ECN/PCN No.: 4500

CONTINUOUS VOLTAGE SMD CRYSTAL OSCILLATOR

ASDDV

Mechanical Dimensions

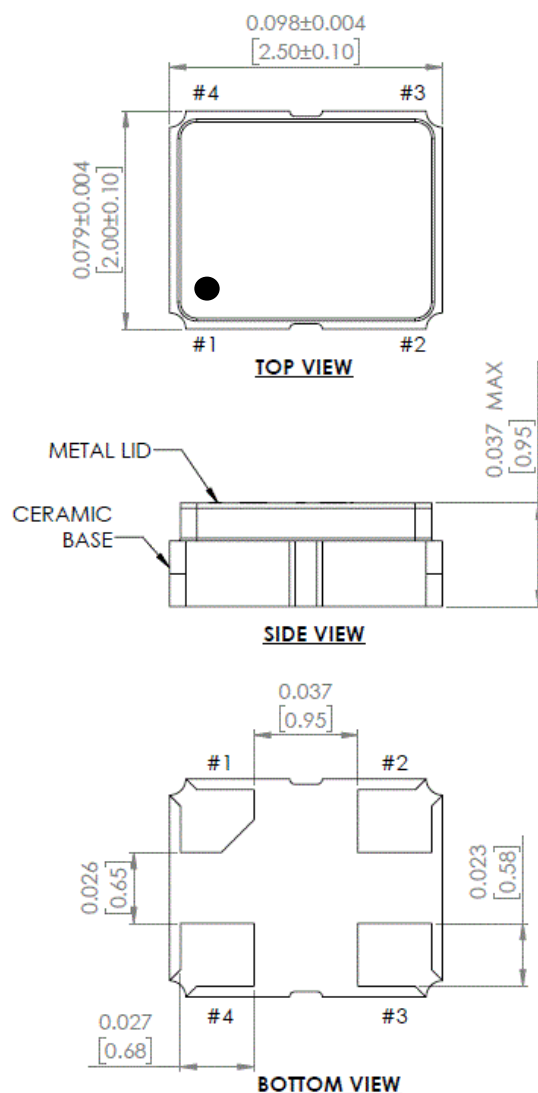
For Manufacturer			
Product Description: ASDDV	Abrakon Part Number / Part Series: CONTINUOUS VOLTAGE SMD CRYSTAL OSCILLATOR	☐ Documentation only ☒ ECN ☐ EOL	☒ Series ☐ Part Number
Affected Revision: F	New Revision: G	Application:	☐ Safety ☒ Non-Safety
Prior to Change: Package (top view), marking scheme: pin 1 dot not included  TOP VIEW			
After Change: Package (top view), marking scheme: pin 1 dot included  TOP VIEW			
Cause/Reason for Change: To facilitate customers with part orientation.			
Change Plan			
Effective Date: 10/27/2022	Additional Remarks: N/A		
Change Declaration: The addition of the pin 1 dot laser-marking does not impact the electrical nor mechanical performance of the device.			
Issued Date: 10/27/2022	Issued By: Brooke Cushman Product Engineer	Issued Department: Engineering	
Approval: Thomas Culhane Engineering Director	Approval: Reuben Quintanilla Quality Director	Approval: Ying Huang Purchasing Director
